# Malahide Community Forum

**An Bord Pleanála Reference : PL06F.304624 - Broadmeadow Way**

Submission of observation Re: Application for approval to An Bord Pleanála by Fingal County Council to carry out a proposed development (Broadmeadow Way), consisting of new greenway (shared footpath and cyclepath), between Malahide Demense and Newbridge Demense.

Photograph 1: Exiting trimmed Hedge at southern end of O'Hanlon's Lane are not consistent with the provision of safe passing width for pedestrians and cyclists

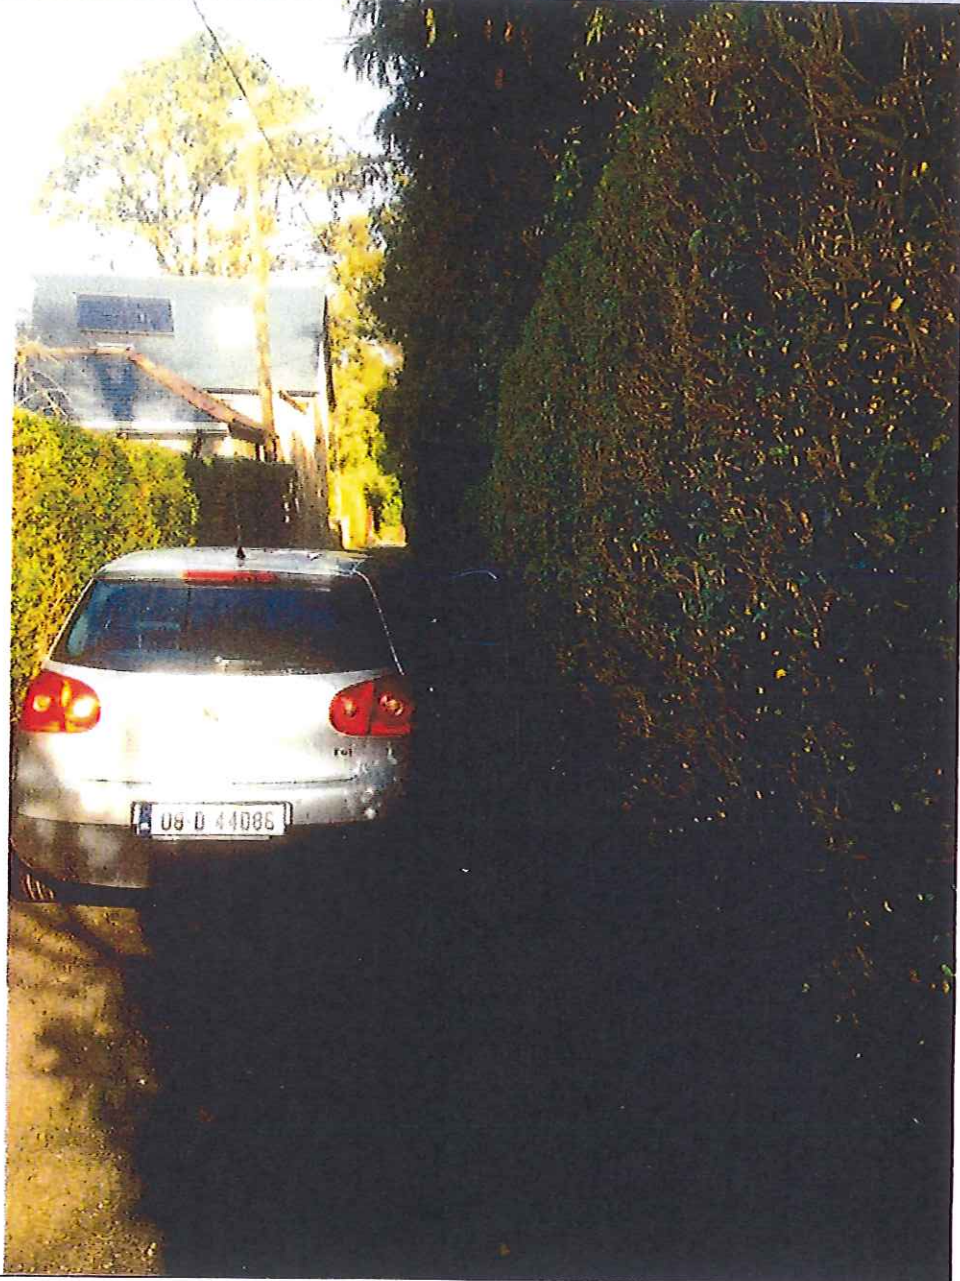
Outlined below are Photographs 1 & 2, showing hedgerows at the southern end of the lane where hedge trimming is proposed. The photographs demonstrate that these hedges are already well maintained and trimmed back regularly by residents.

Photograph 2: Exiting trimmed Hedge at southern end of O'Hanlon's Lane are not consistent with the provision of safe passing width for Pedestrians and Cyclists

**Image 1: Source: Google Maps showing the existing junction at the Southern/Malahide Road end of O'Hanlon's Lane**

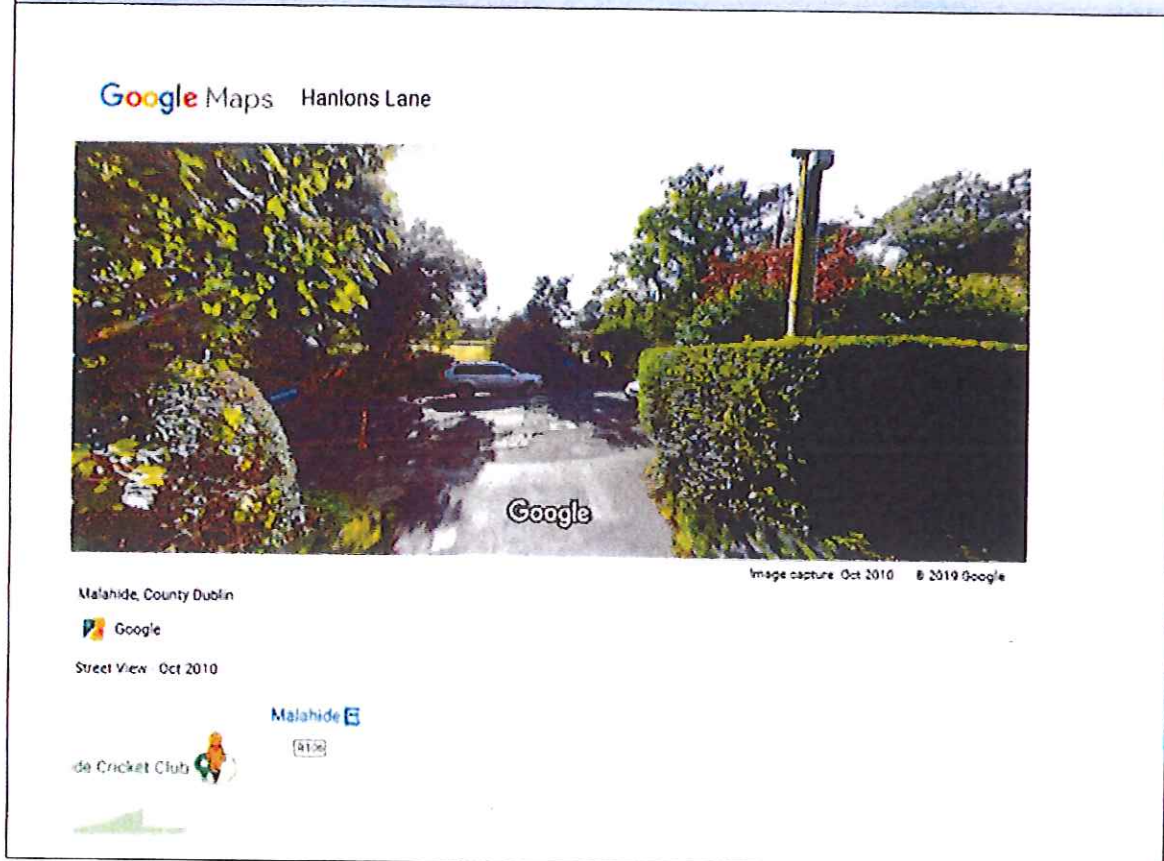
Dimensions of existing junction when considered as minor road to major road in accordance with the IEI design for roads recommendations and the RSA design for geometric junctions recommendations are summarised as:

The existing junction at the southern/Malahide Road end of O'Hanlon's Lane does not meet any of the design requirements for width of a minor road, sight lines for traffic from the minor road, traffic sight lines from the major road to the minor road.

Photograph 3: Safety hazards of HGV and service vehicles at O'Hanlon's Lane southern end

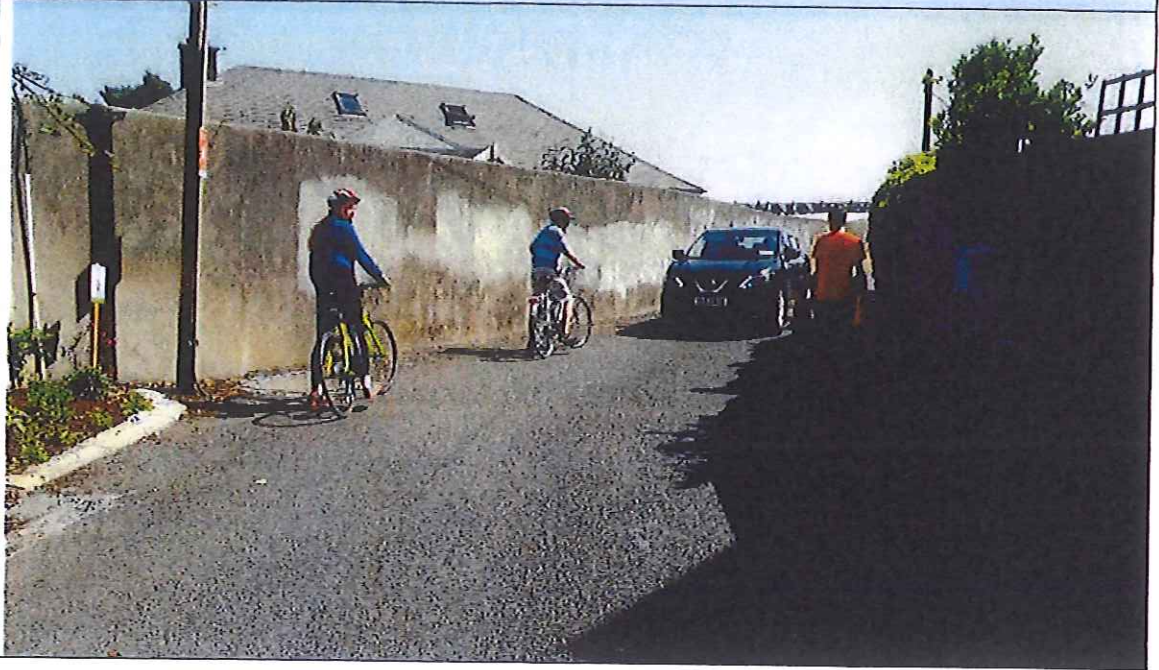
Photographs 3 - 12 below illustrate some potential sight line hazards.

Photograph 5: Hazardous lines of sight into oncoming vehicular traffic for users at O'Hanlon's lane northern end

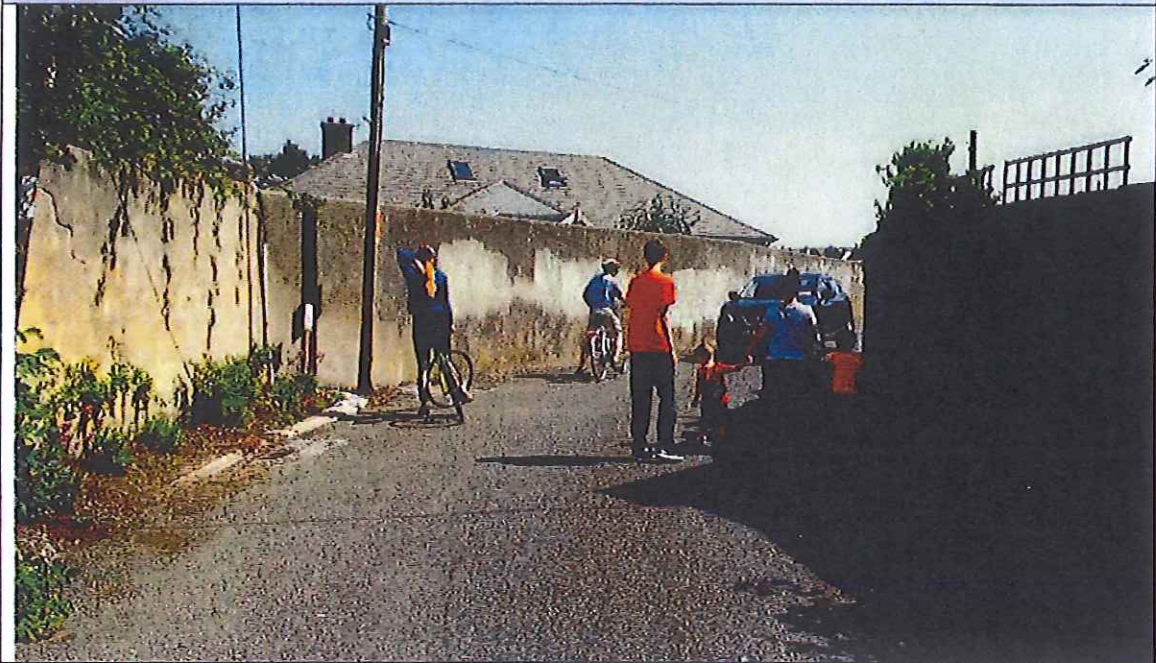
Photograph 4: Hazardous lines of sight into oncoming vehicular traffic for users at O'Hanlon's lane northern end

Photograph 13: Exiting trimmed Hedge at southern end of O'Hanlon's Lane are not consistent with the provision of safe passing width for Pedestrians and Cyclists

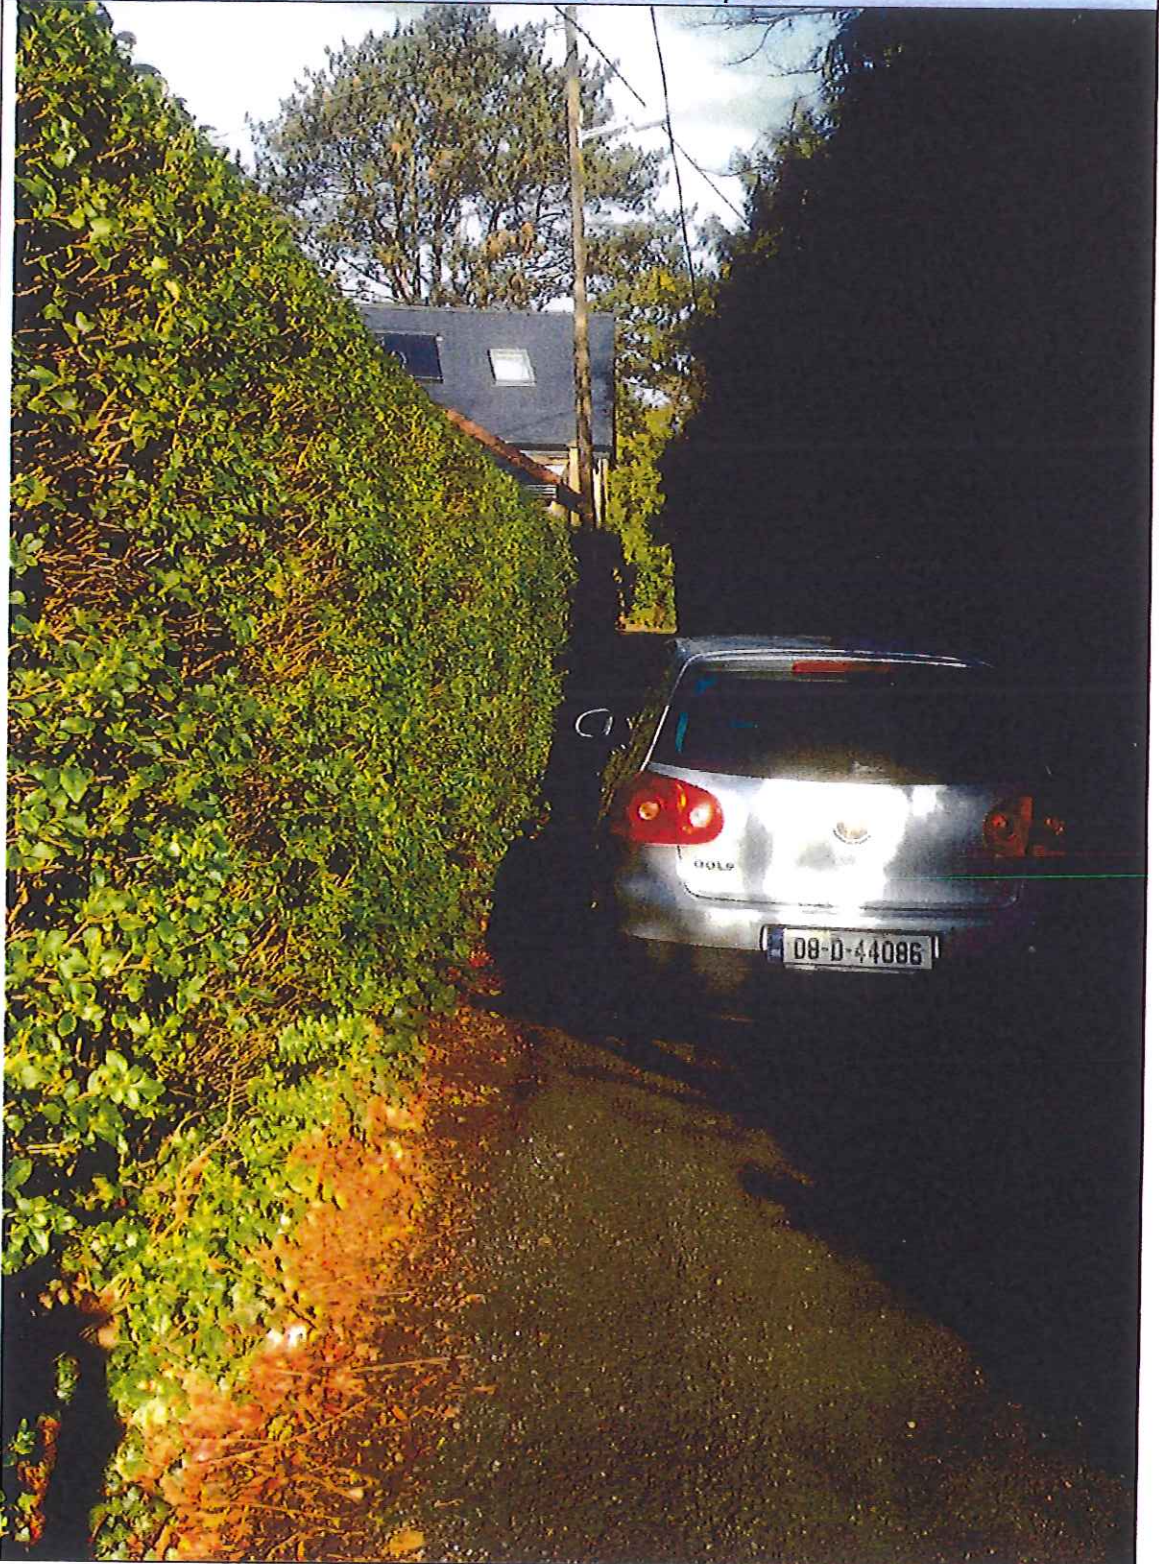
Photograph 13 & 14 below illustrates insufficient passing distances. This illustration would be further compounded by oncoming HGV traffic.

Photograph 14: Exiting trimmed Hedge at southern end of O'Hanlon's Lane are not consistent with the provision of safe passing width for Pedestrians and Cyclists

Photograph 15: Street parking is an established norm for visitors and those working at or delivering to households on the lane.

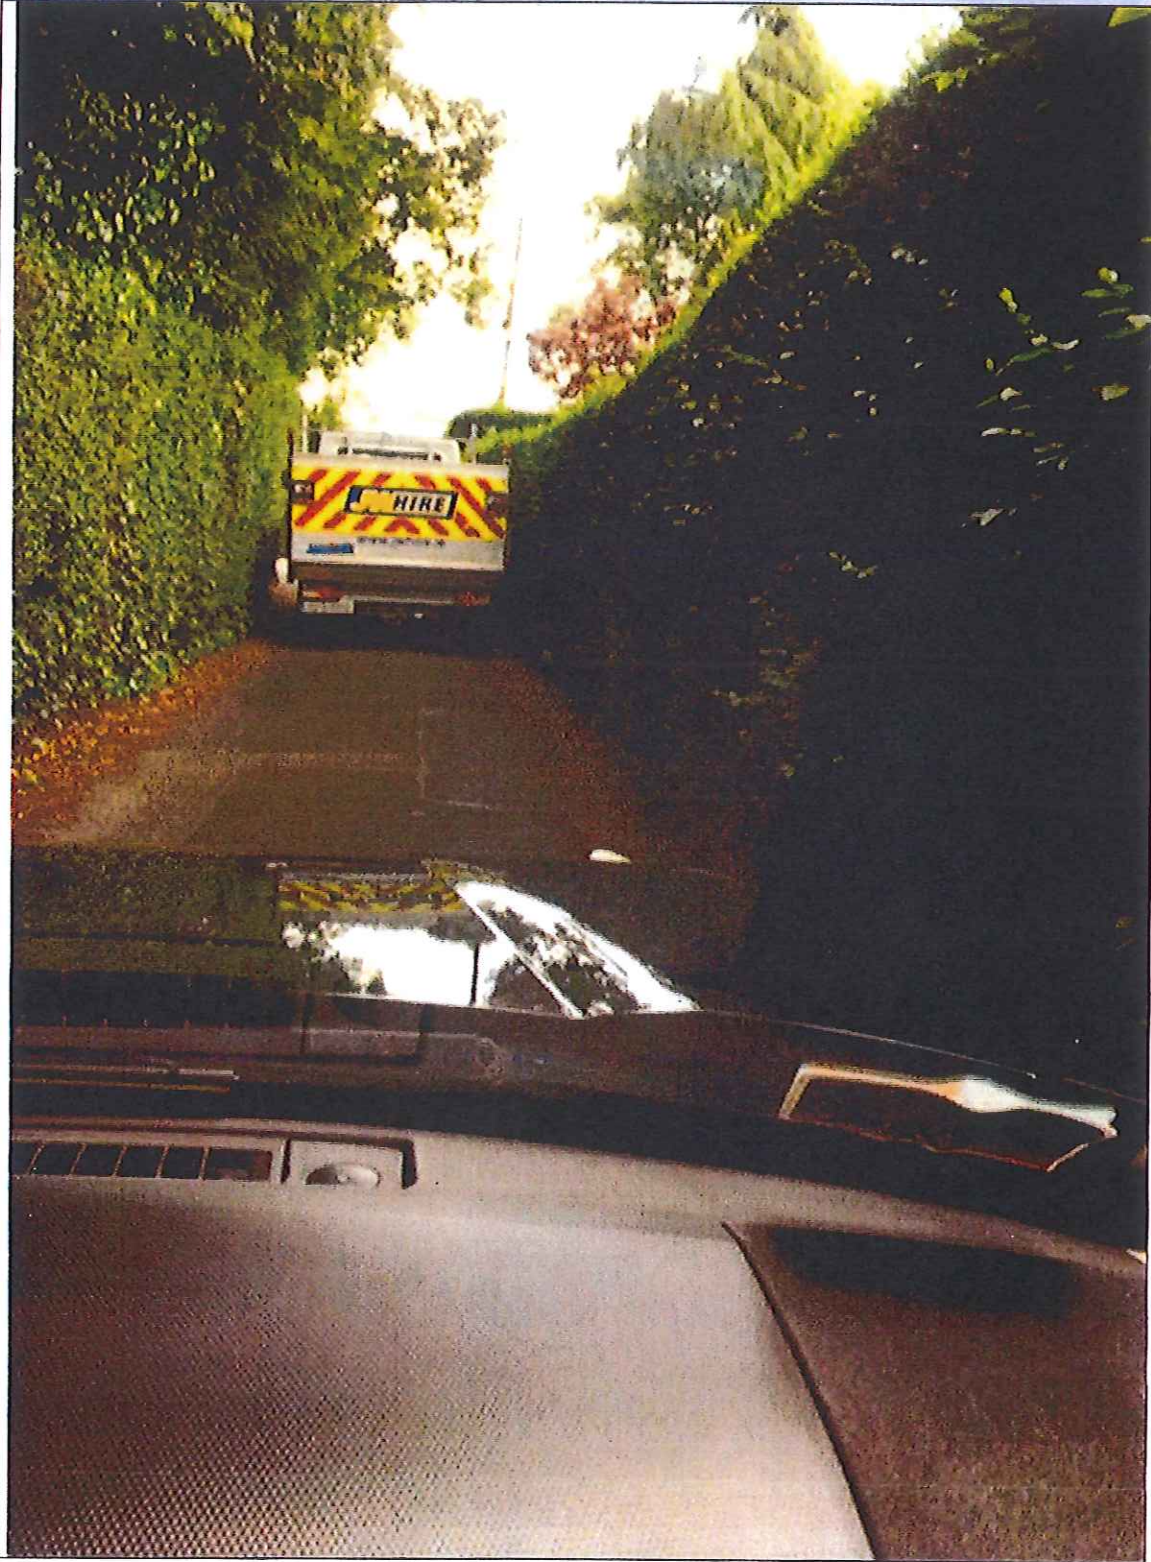
Photographs 15 & 16 below provide illustrative examples of these challenges that have not been addressed in the design.

Photograph 16: Management of HGV and Service Vehicles at O'Hanlon's Lane southern end
